# Access Compliance Report

### (Curb Ramps)

Intersection ID: 52622	Main Street: HERITAGE_POND_DR	Cross Street: ALEXANDER_COMMONS_DR	Location: S
ADA ID: C80815155C5D	Ramp Type: Perp	Initial Pass/Fail: Fail	Overall Compliance: No
Severity Score: 25			
Codes/Mitigation Info/Possible Solution		Field Measurements/Component Compliance

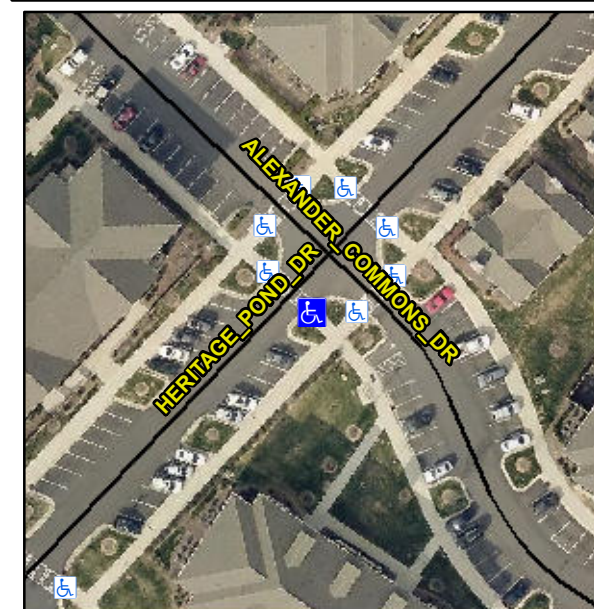
Compliance	Description	Data	Compliance	Description	Data
N/A	Ramp Length (in)	97.5	No	Ramp Slope (%)	18.7
Yes	Ramp Width (in)	87.0	Yes	Ramp XSlope (%)	1.1
N/A	Flare Type LT	N/A	N/A	Flare Type RT	N/A
N/A	Flare Slope LT (%)	N/A	N/A	Flare Slope RT (%)	N/A
N/A	Flare Traversable LT?	N/A	N/A	Flare Traversable RT?	N/A
N/A	Landing Length (in)	N/A	N/A	DWS Provided?	N/A
N/A	Landing Width (in)	N/A	N/A	DWS Contrast?	N/A
N/A	Landing Slope (%)	N/A	N/A	DWS Length (in)	N/A
N/A	Landing X Slope (%)	N/A	N/A	DWS Full Width?	N/A
N/A	Landing Curb? (Y/N)	N/A	N/A	DWS Offset (in)	N/A
N/A	Shared Landing?	N/A			
N/A	Gutter Ponding?	N/A	N/A	Gutter Slope (%)	N/A
N/A	Gutter Lip Ht (in)	N/A	N/A	Gutter X Slope (%)	N/A
N/A	Painted X Walk1?	Yes	N/A	Painted X Walk2?	N/A
	X Walk 1 Direction	To NW		X Walk 2 Direction	N/A
N/A	X Walk 1 Width (in)	86.0	N/A	X Walk 2 Width (in)	N/A
	X Walk 1 Slope (%)	4.0		X Walk 2 Slope (%)	N/A
	X Walk 1 X Slope (%)	0.6		X Walk 2 X Slope (%)	N/A

**Remove & Replace Entire Ramp.**
